Village of Arlington Heights
Conceptual Plan Review Committee
Community Room, 3rd Floor
Arlington Heights Village Hall, 33 S. Arlington Heights Rd.
March 8, 2023
6:30 PM

**Conceptual Plan Review Committee
3/8/2023**

REPORT OF THE PROCEEDINGS OF
THE CONCEPTUAL PLAN REVIEW COMMITTEE

Project Title: Patton School Building Expansion

NEW DECK & EXISTING PARTIAL FLOOR PLAN

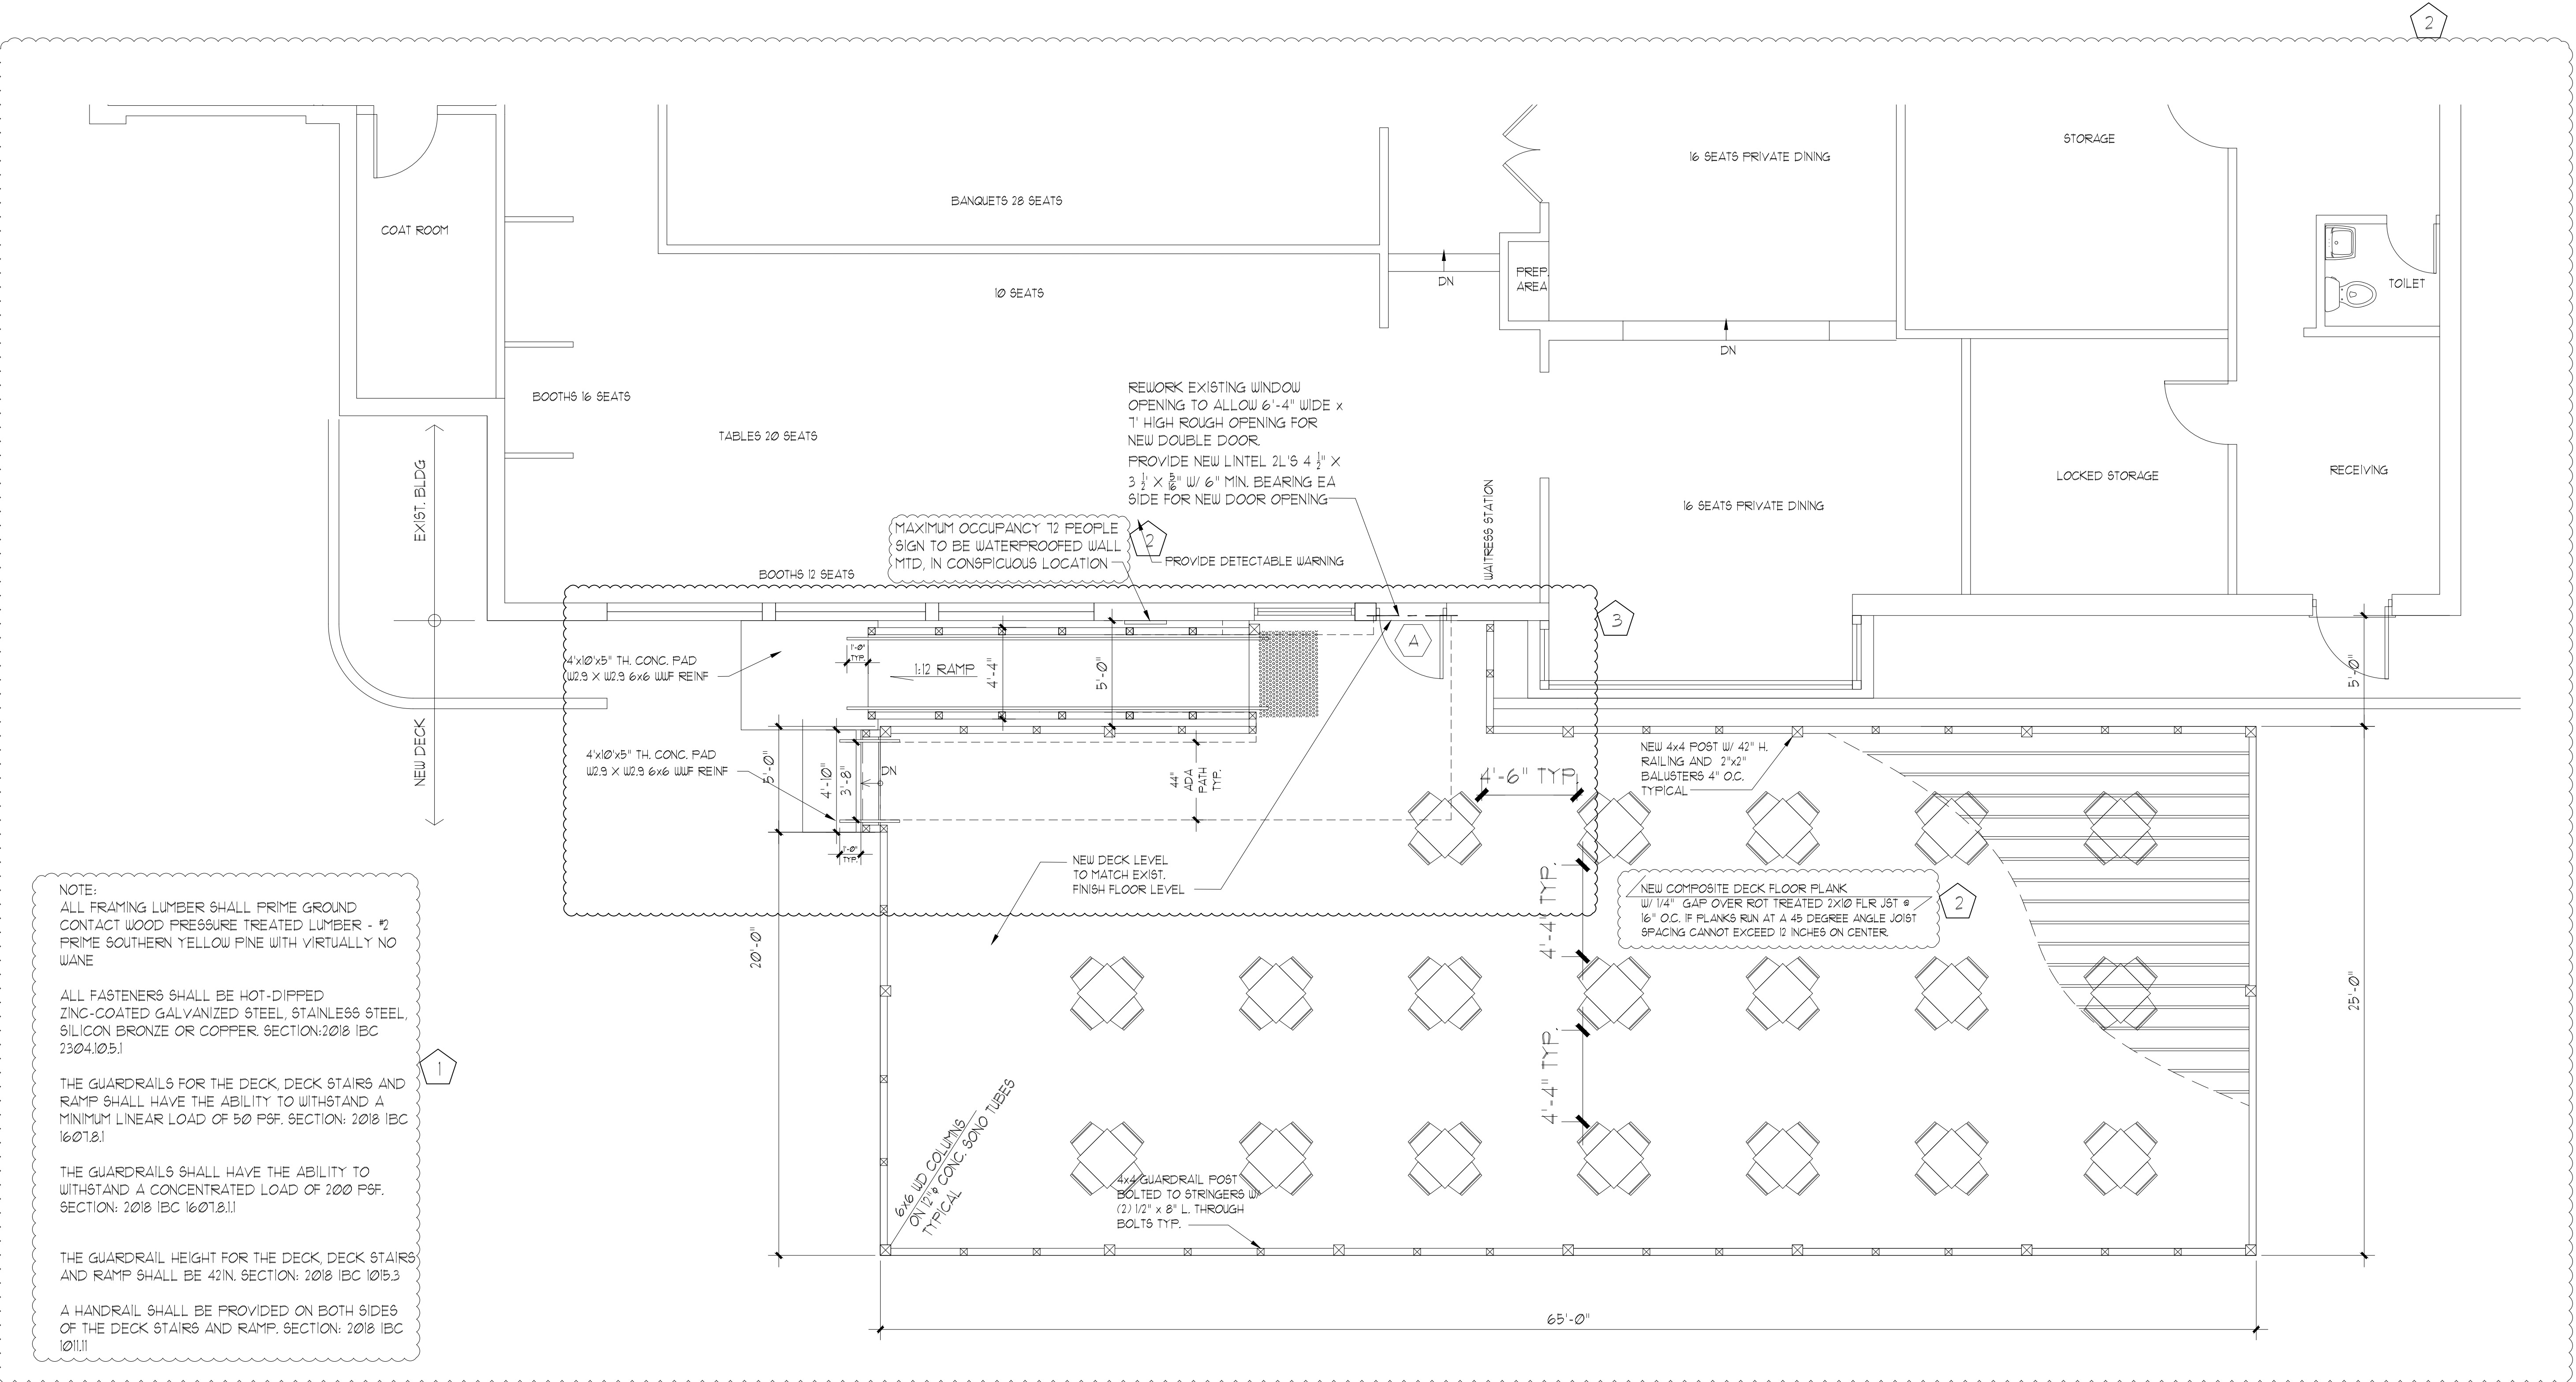
As mentioned, the petitioner will be removing parking within the northern parking lot, and constructing a deck. The petitioner is proposing to remove the asphalt area surrounding the deck, and adding shrubbery around the perimeter of the deck. Staff encourages the use of landscaping to enhance the experience of diners, appearance of the property, and buffer the adjacent residences from potential noise. During the formal Plan Commission review process, staff will evaluate the existing site landscaping to ensure that it conforms to all code requirements where necessary and feasible. Additionally, Staff will evaluate the condition of the parking lot to determine if any repairs, resurfacing, or restriping is needed.

During Staff Development Committee Review, the Engineering Division commented that a full curb, and sidewalk restoration would be needed across the entrance to the northern parking lot. As Arlington Heights Road is under the jurisdiction of IDOT, their review and approval would be required. However, this was in response to a prior version of the plan where the northern lot would be fully closed, whereas under the current plan some parking in this lot would be maintained. During the formal Plan Commission review process, it will be determined if IDOT approval is needed with the revised change to the northern parking lot.

The petitioner shall provide the village with a timeline for installation of all proposed improvements.

2 FLOOR PLAN - PLUMBING
SCALE : 1/4" = 1'-0"

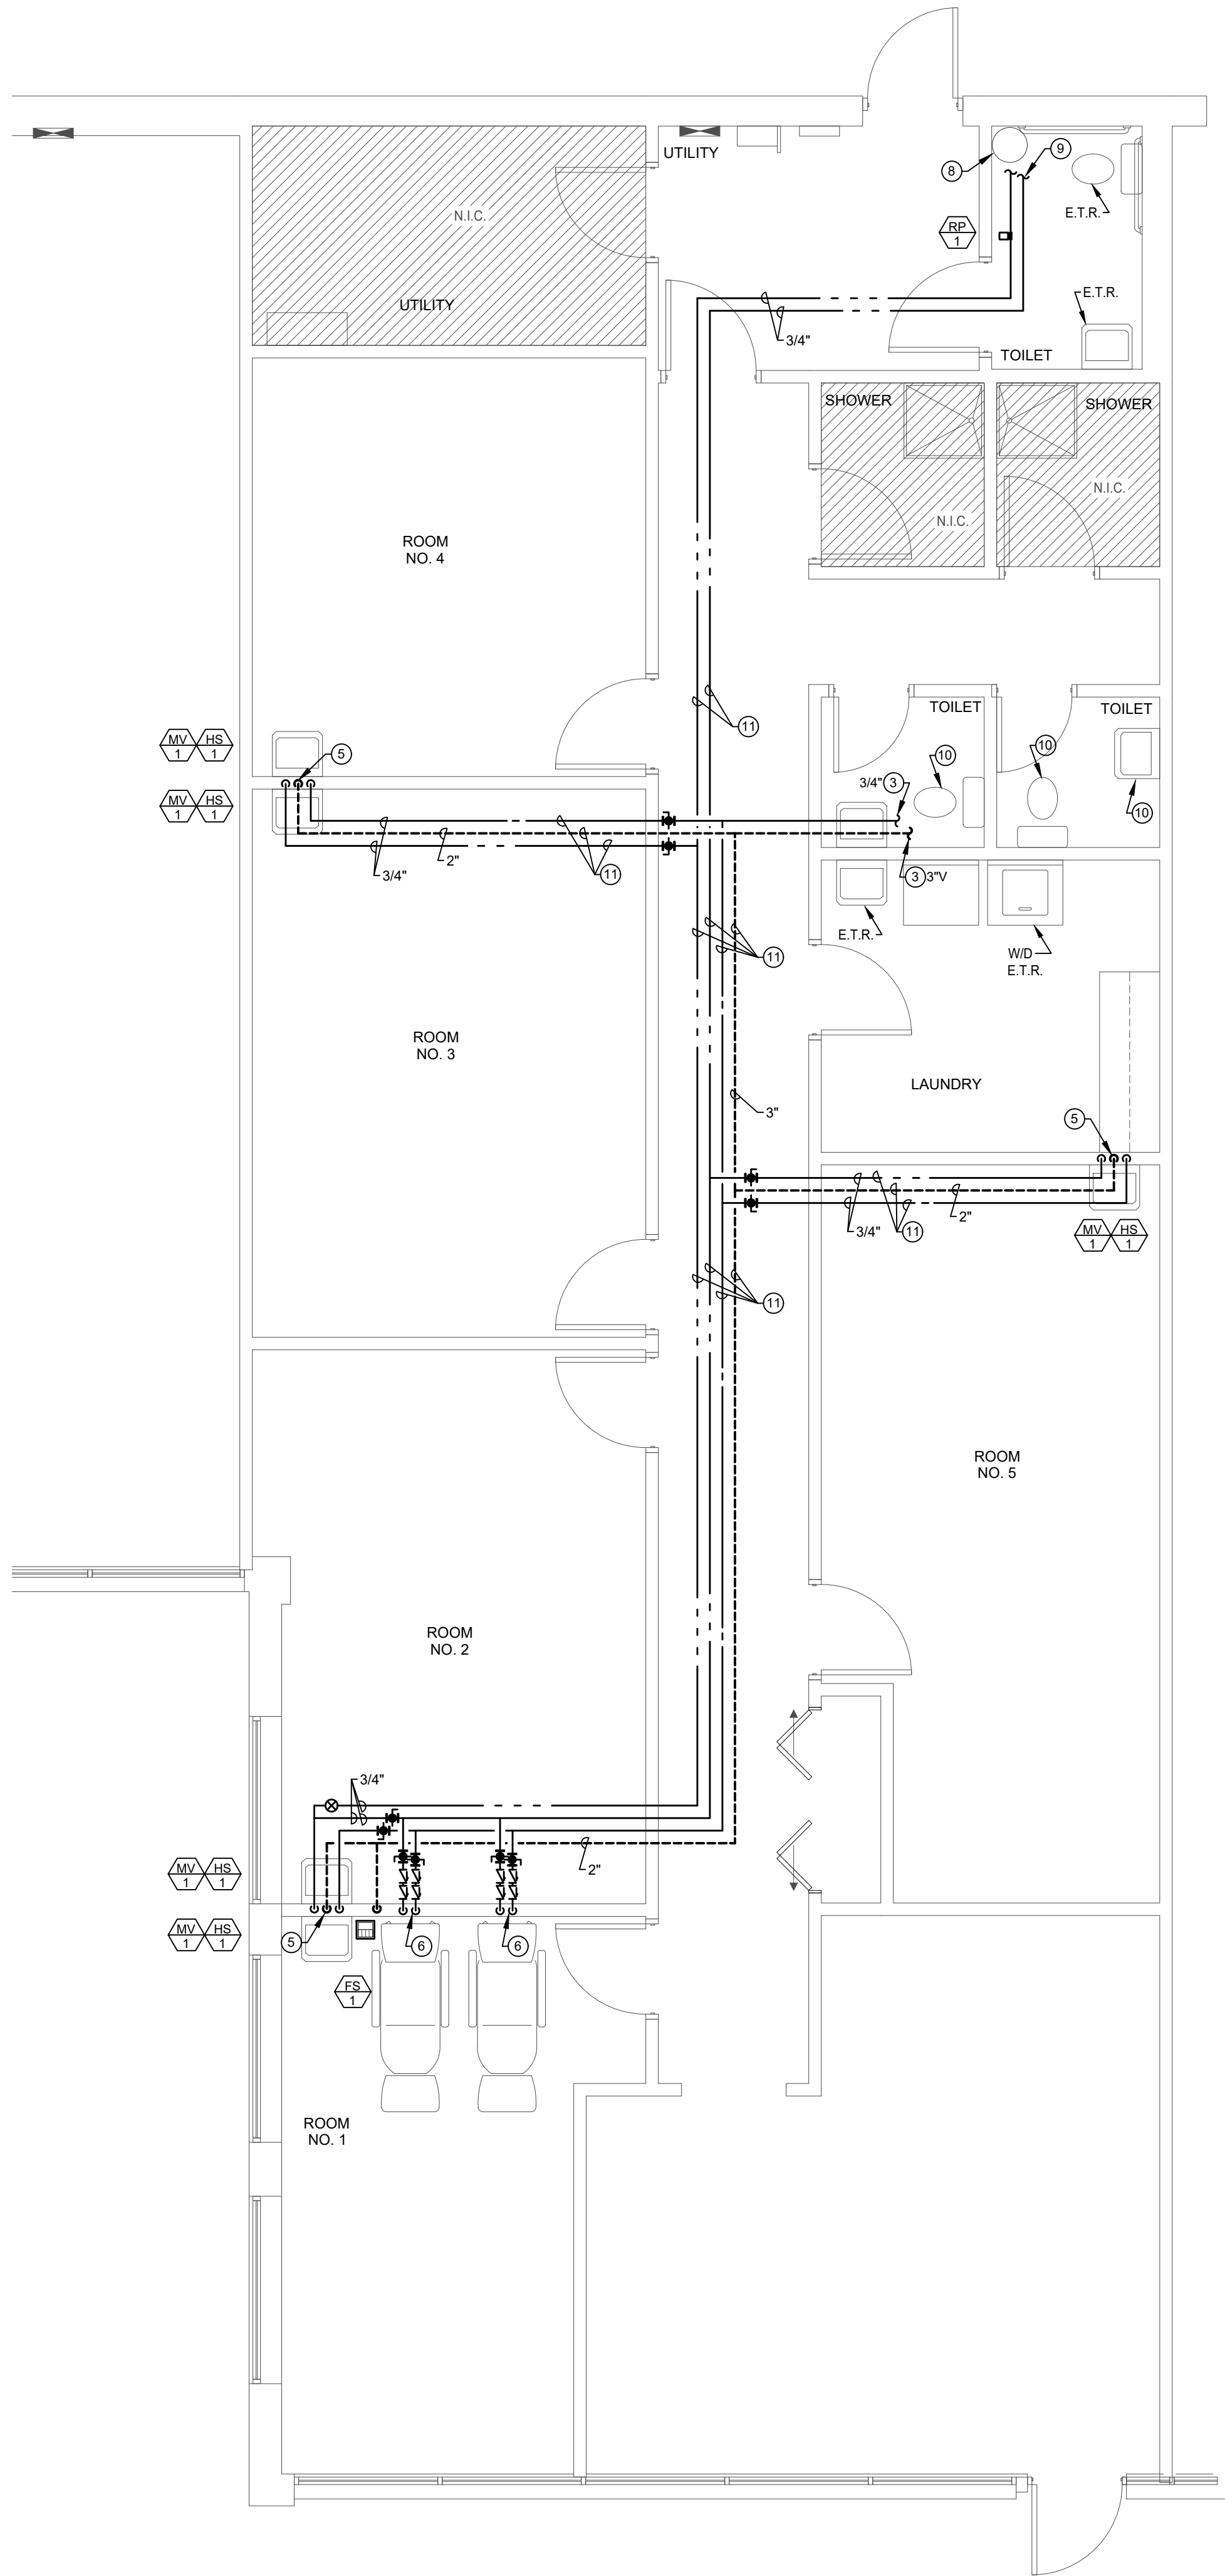
3. A private "Reduced Pressure Zone" (RPZ) is required to isolate the medical / dental office room the other units in the building.
4. These are preliminary comments only and should not be relied upon as identification of the only major issues. The Staff Development Committee reserves the right to change its position upon submittal of a formal application and detailed review.
